DATE: January 14, 2021
TO: All Planholders
SUBJECT: **ADDENDUM NO. 5**
PROJECT: Greene Central School District
2019 Capital Improvements – Phase 2
IBI Reference No. 123890

SED REVIEW NOS. 20-0336, 20-0337, 20-0338, and 20-0339

1 AHU/FCU COIL PIPING SCHEMATIC
 AD5-M1 Scale: NTS

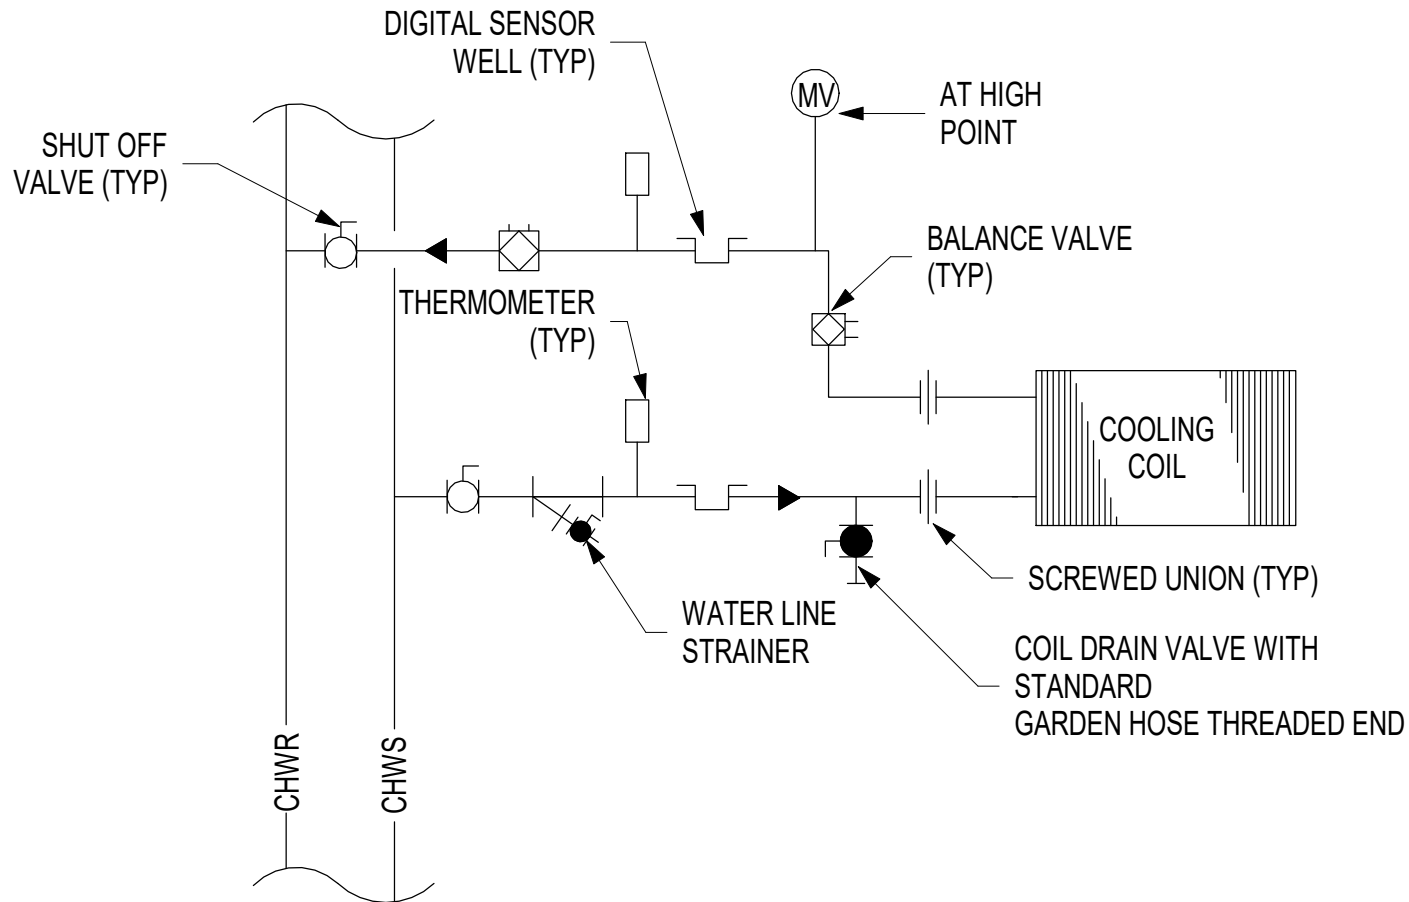
1. Question: There is no piping detail for fan coil units or the air handler units. Please advise.
 - a. **Clarification:** Refer to attached Drawing AD5-M1 – AHU Coil Piping Detail.

1. Question: There is no piping detail for fan coil units or the air handler units. Please advise.
 - a. **Clarification:** Refer to attached Drawing AD5-M1 – AHU Coil Piping Detail.
